VALLEJO CENTER

NEW CLASSROOM BUILDING

DSA APPROVAL SET
DECEMBER 8, 20005

AS BUILTS

1 PARTIAL FIRST FLOOR RCP
SCALE 1/8" = 1'-0"

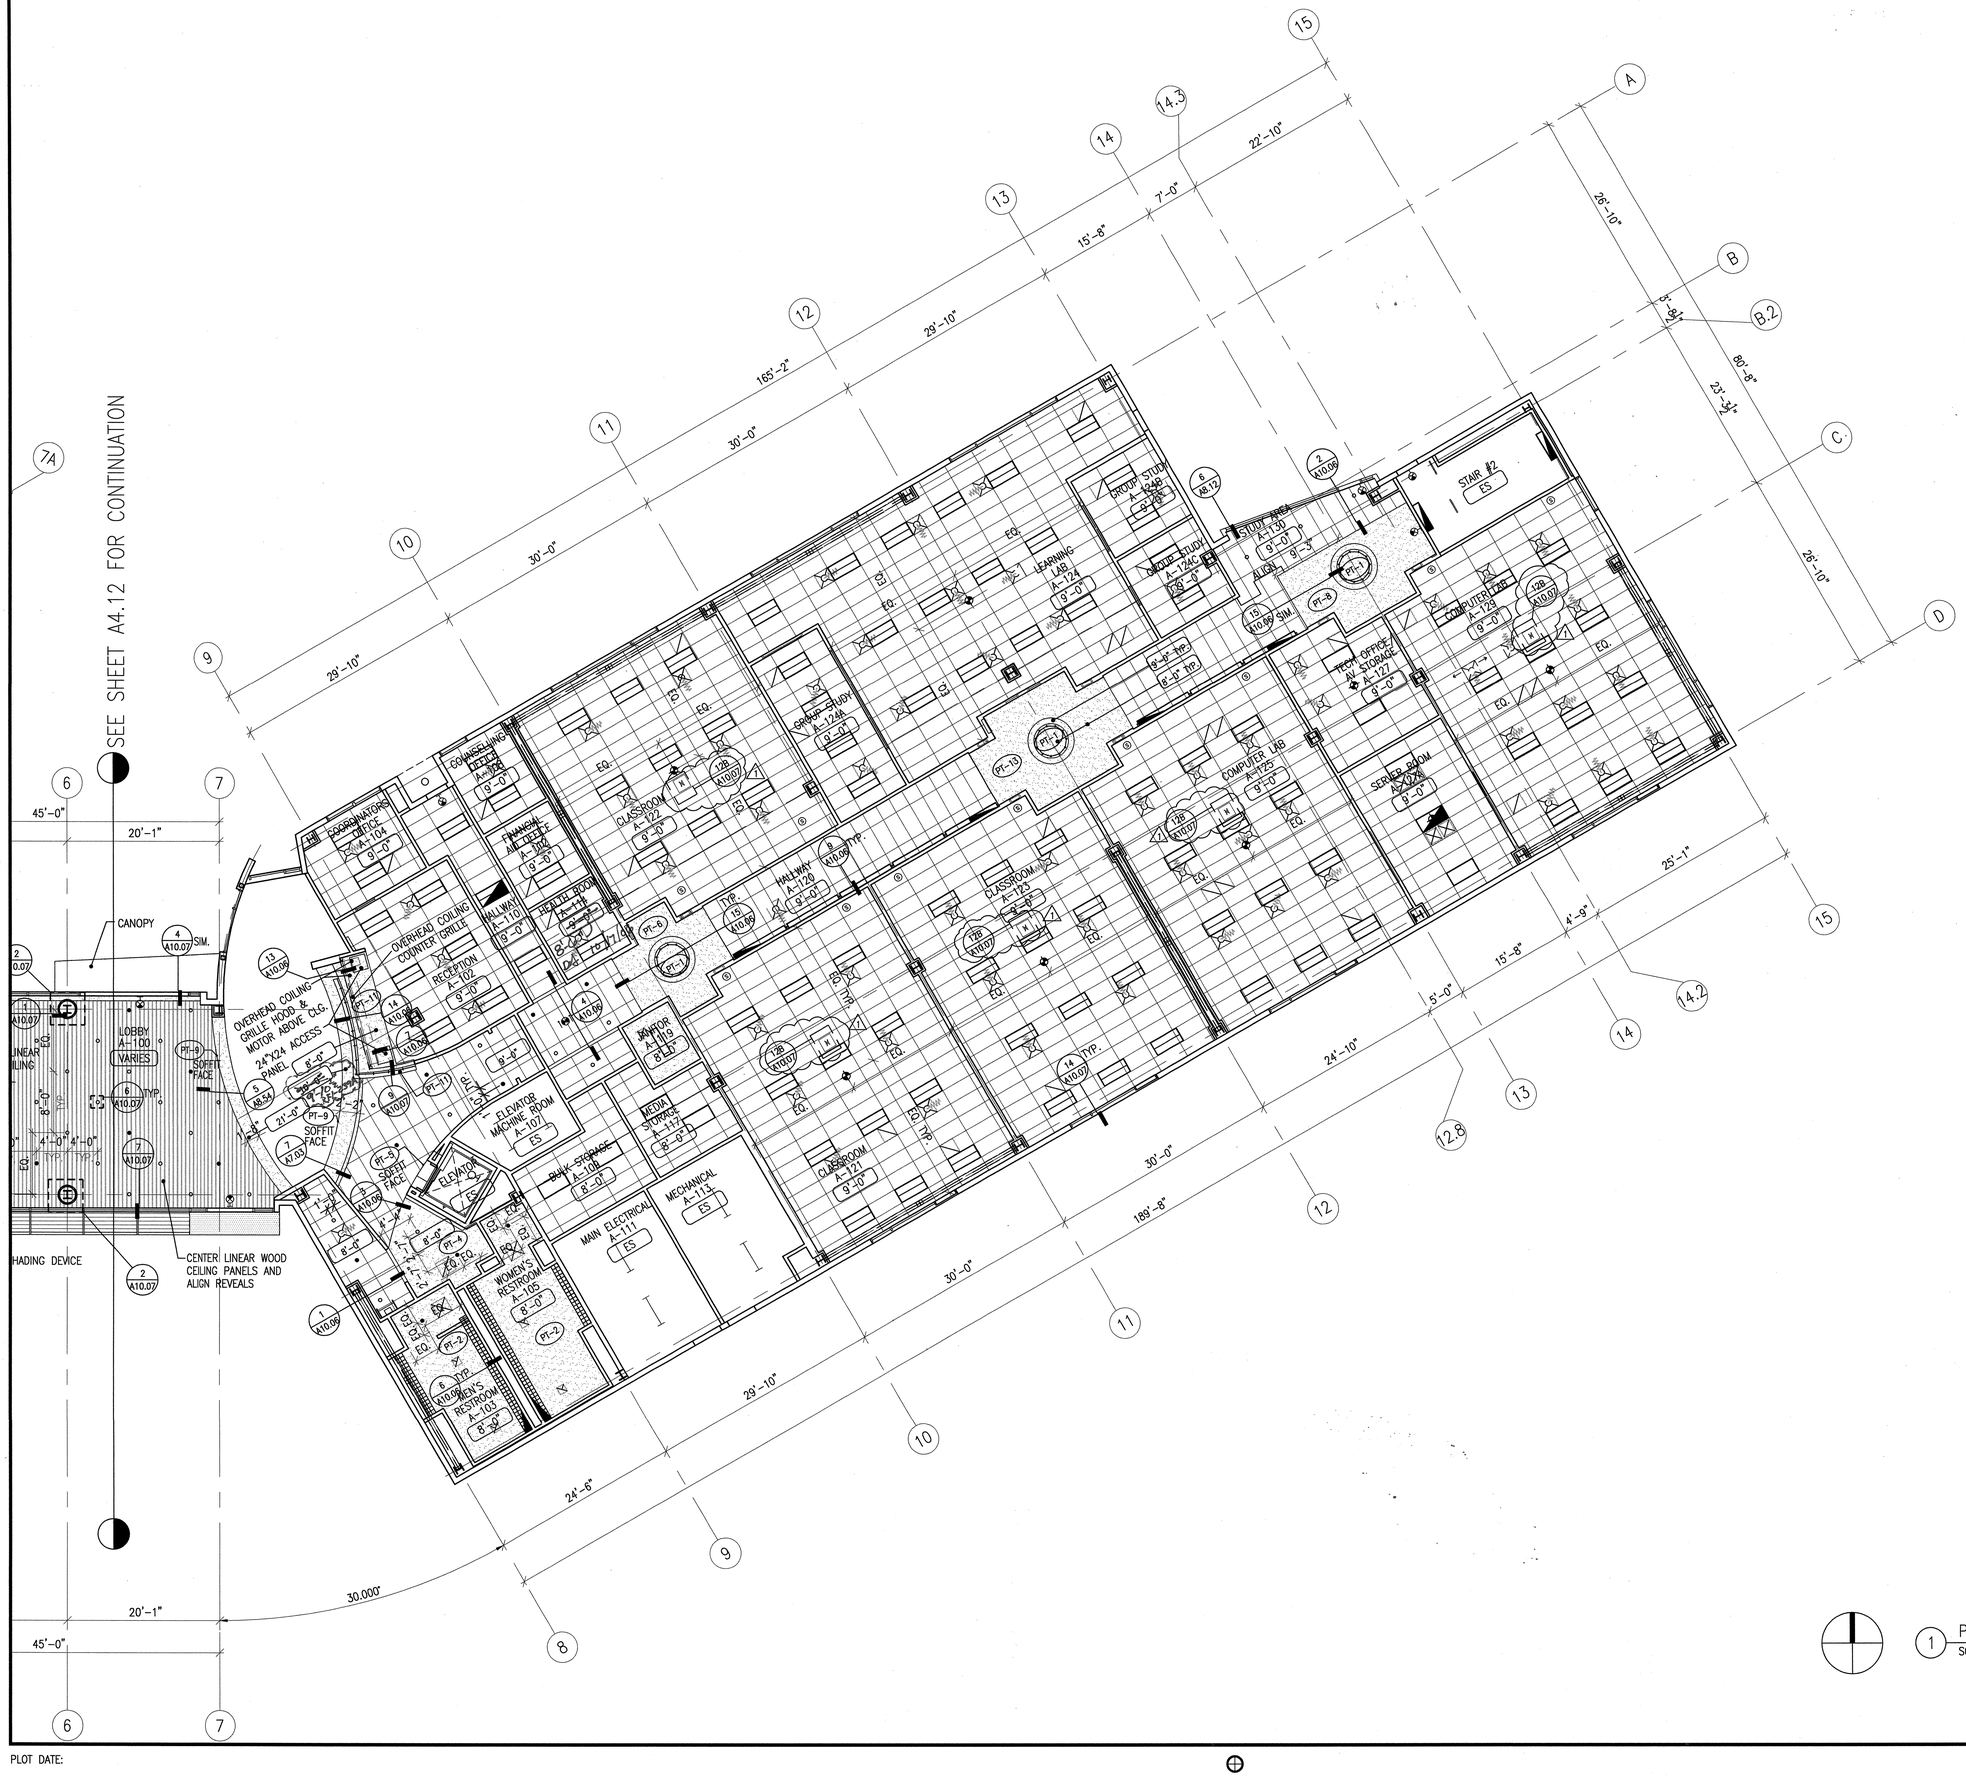
1. Is the attached detail acceptable for use at suspended ceilings, light fixtures, and seismic wires for acoustical ceilings?
Drawing A4.12 requires us to use detail 10/A10.06 for the perimeter soffit framing in Room B101. Detail 10/A10.05 implies that the 2x12 blocking at the perimeter is not required for framing to the roof structure. Detail 10/A10.05 implies that the metal decking over room B101 will have concrete fill, however this concrete fill in the metal decking over Room B101 is not shown on the structural drawings or the roof section details for this area of the Building.

1 PLAN SECTION PROJECTED WINDOW
SCALE 1 1/2" =1'-0"
REF A-DTEWP-04

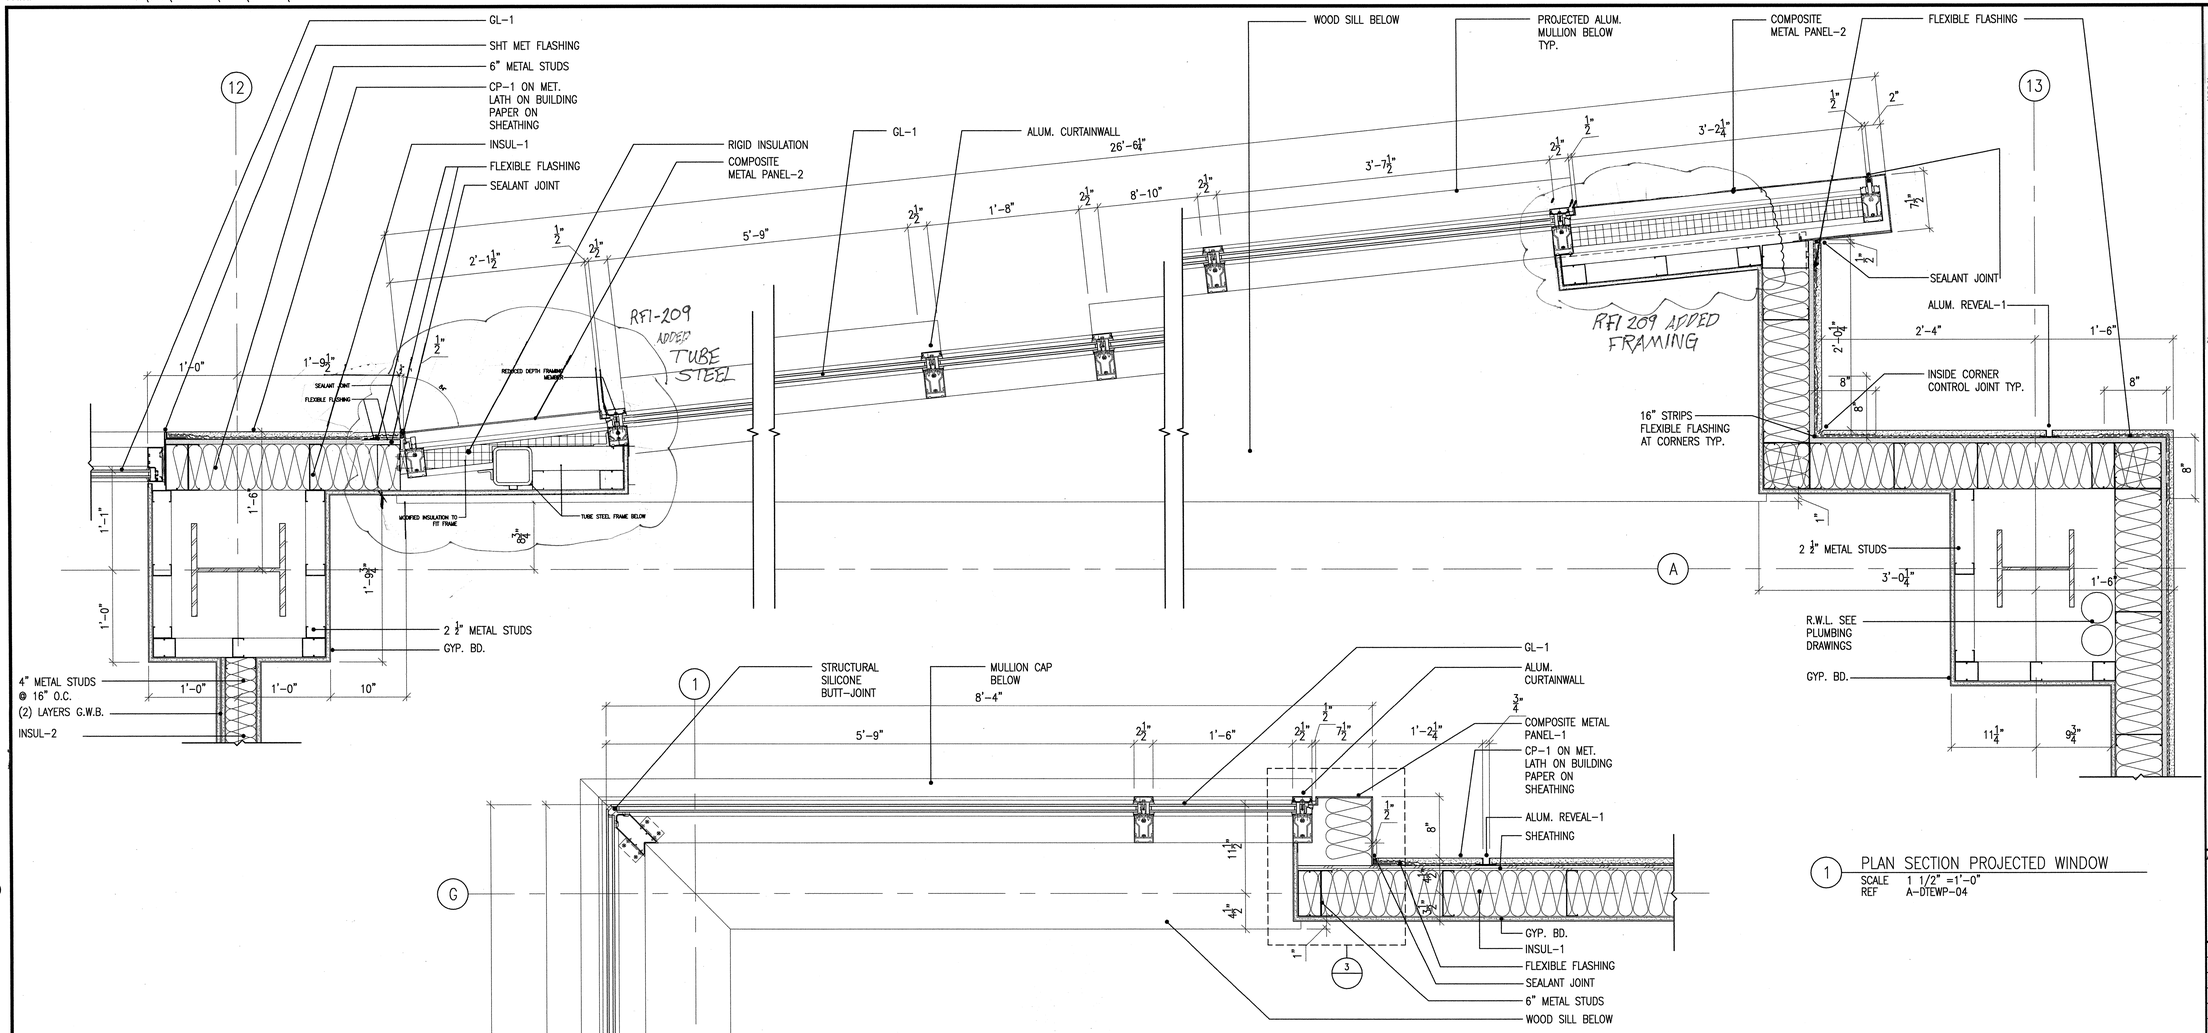
Question
In our RFI-209 we indicated our concern for the projected window attachment at the East end to the wing wall shown in detail 5/A8.02. The following is a portion of our RFI-209:
The only window framing attached available at the East end is at the horizontal window framing to the (East end) metal wing wall.
